T10/04-383r2

From
Michael Banther, HP

Subject
FCP-3 Clarification to TPRLO

Date
18 January 2005

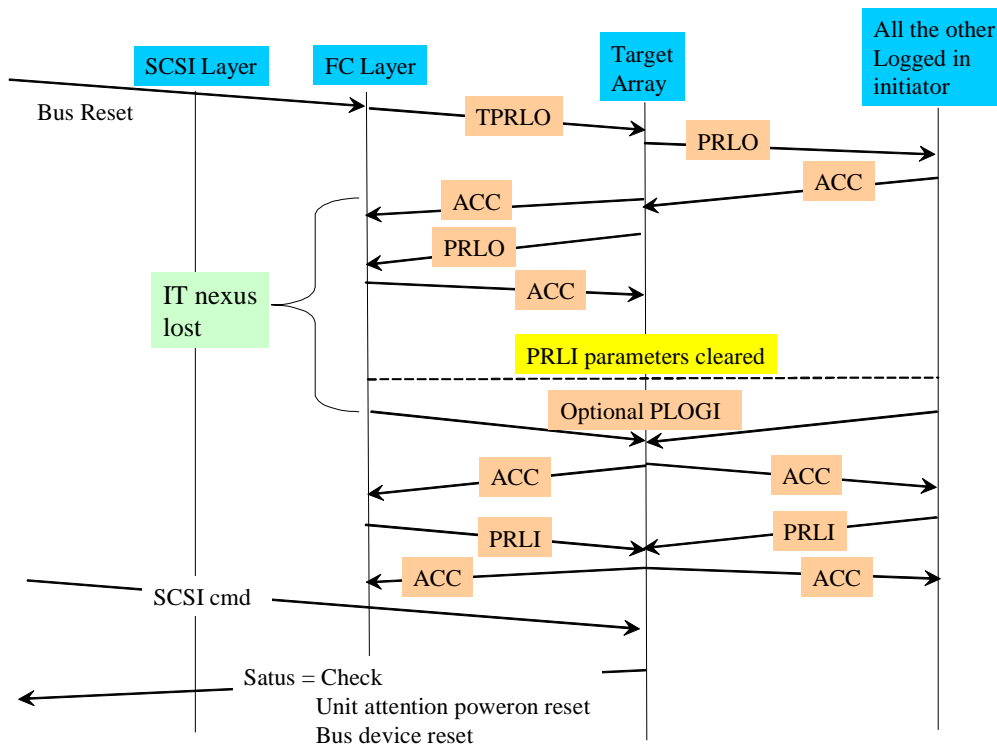
HP has become aware that some target devices do not log out all initiators during a Third Party Process Logout when the GLOBAL bit is set to one. This behaviour results in PRLI parameters remaining set. HP believes that the diagram below shows the correct behaviour.

- 3 For TPRLO (Third Party Process Logout), actions listed shall be performed when the GLOBAL bit is set to one. If the GLOBAL bit is set to zero, then the actions listed under PRLI/PRLO shall be performed for the designated initiator. See [FC-LS-FCFS](#).

- 6 A target port should send PRLO to all logged-in initiator ports that are logged-out as a result of processing TPRLO with the global bit set to one. The PRLO(s) may be sent before or after sending the LS_ACC for the TPRLO.
